**Proposed Temporary Warehouse (excluding Dangerous Goods Godown) with Ancillary
Open Storage of Construction Materials and Facilities for a Period of 3 Years in
“Other Specified Use” annotated “Railway Reserve” Zone,
Lot 4115 (Part) in D.D. 104, Kam Tin, Yuen Long, New Territories**

(S.16 Planning Application No. A/YL-KTN/1222)

Responses-to-Comments

(Application No. A/YL-KTN/1222)

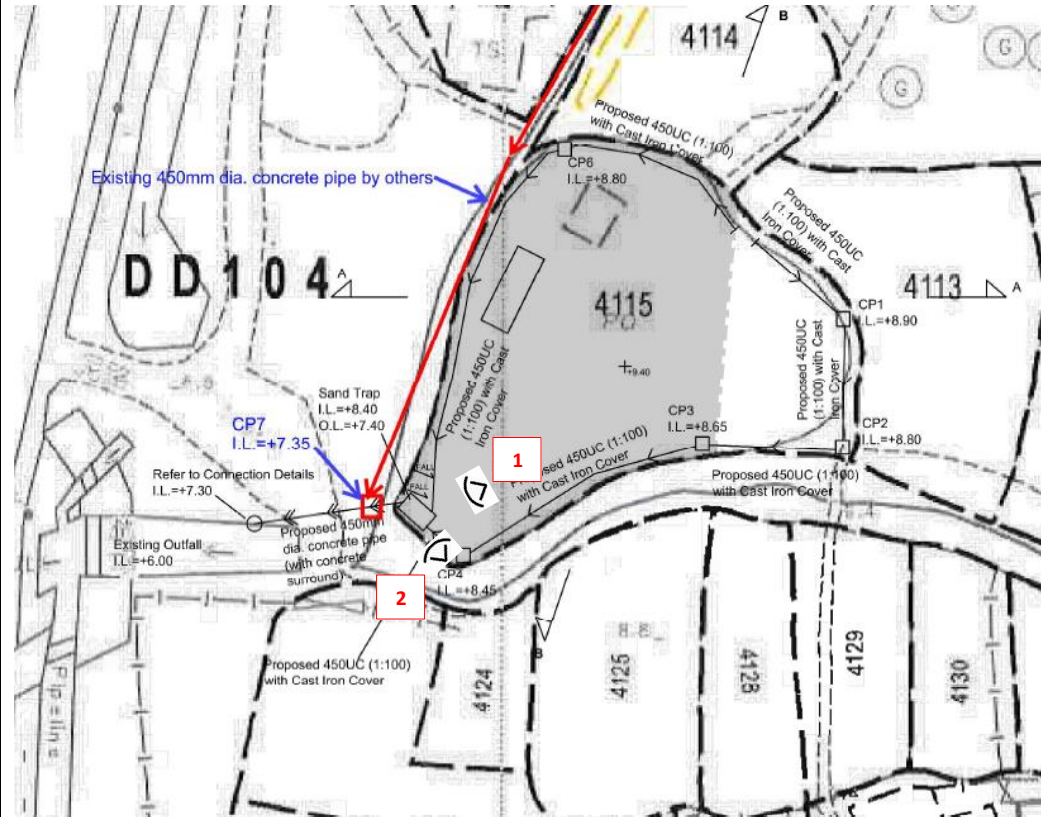
Departmental Comments		Applicant's Responses
1. Comments of the Chief Engineer/Mainland North, Drainage Services Department (Contact Person: Ms. Jessica KWAN; Tel: 3965 8924)		
(a)	Please note that the condition record of existing drainage facilities re-submitted by the applicant is not acceptable due to the following reason. (i) Photo 9: Debris were found in existing drainage facilities that water flow would be obstructed.	Debris found in photo 9 has been cleaned by the applicant. Photographic records are provided as follows:
